Company	Trenz Electronic GmbH
PCN Number	PCN-20190829
Title	TEB0724-02 Under Voltage Protection Change
Subject	Trenz Electronic TEB0724 Hardware Change
Issue Date	2019-09-05

affected product
TEB0724-02

#1 Replaced R40 by 953kOhm and R44 by 147kOhm

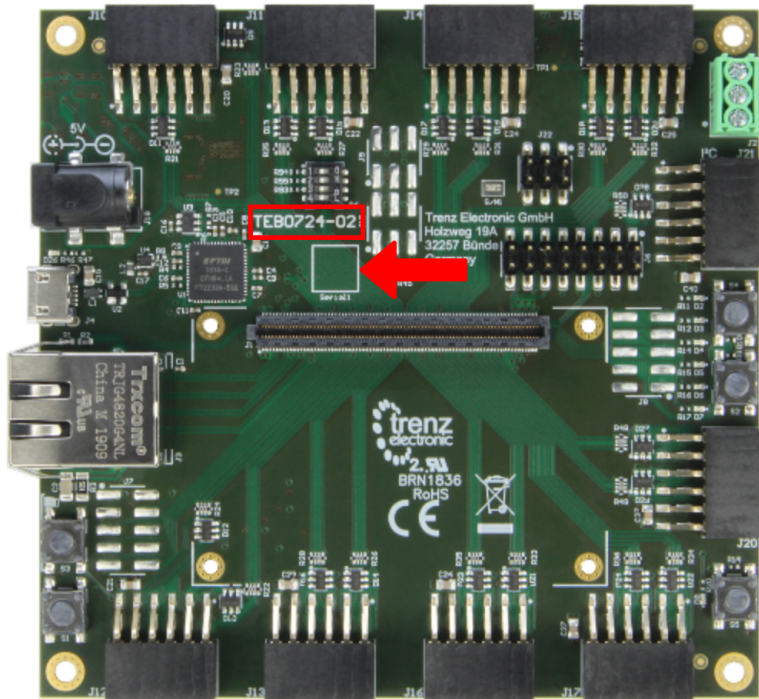
Type: BOM change

Reason: Large start up currents led due to adverse conditions (e.g. weak powersupply, long wires, increased contact resistance) to a voltage drop below the under voltage lock out limit of the input protection circuit.

Impact: Under voltage protection limit is decreased to 4.06V, which gives a larger margin for a voltage drop during start up.
